Proposed changes to recob::Hit

Erica Snider

April 2, 2024

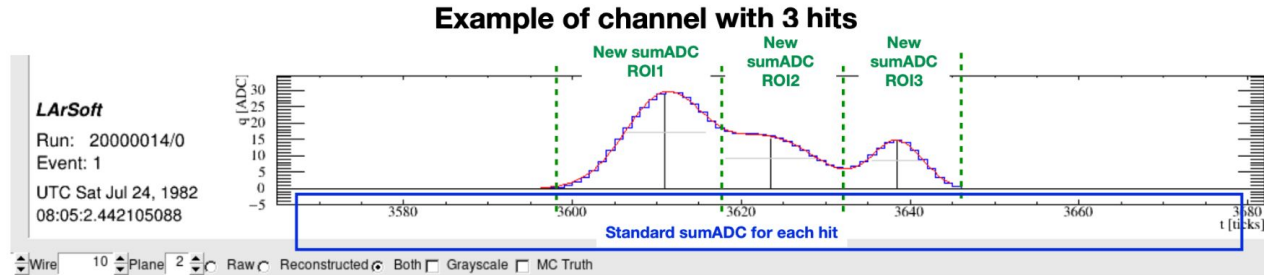
Each hit has distinct value of Integral

All hits in ROI get same value of SummedADC

- This is a known “feature” of GausHitFinder
 - Unclear from header comments that this is possible

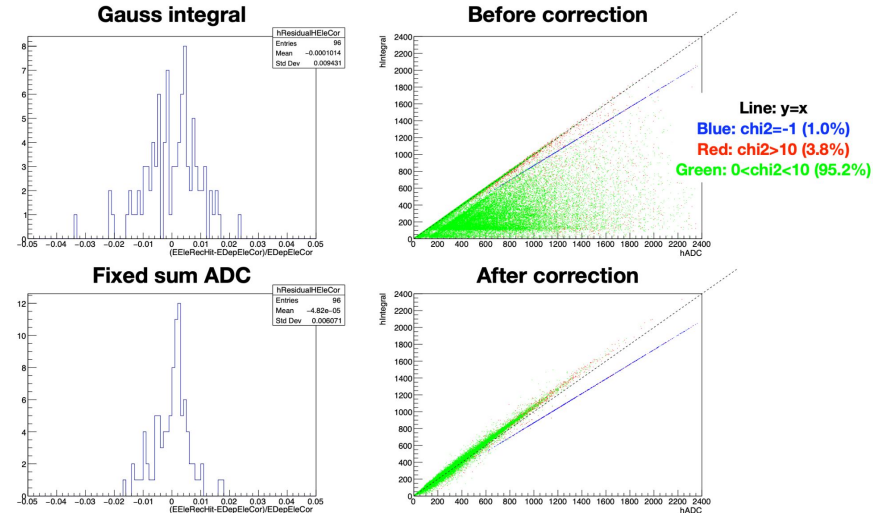
- DUNE proposes a “fix”

- Uses fitted sigmas to define region for ADC sum, sharing between overlaps

- After the fix
 - SummedADC tracks Integral
 - Resolution in some cases improves
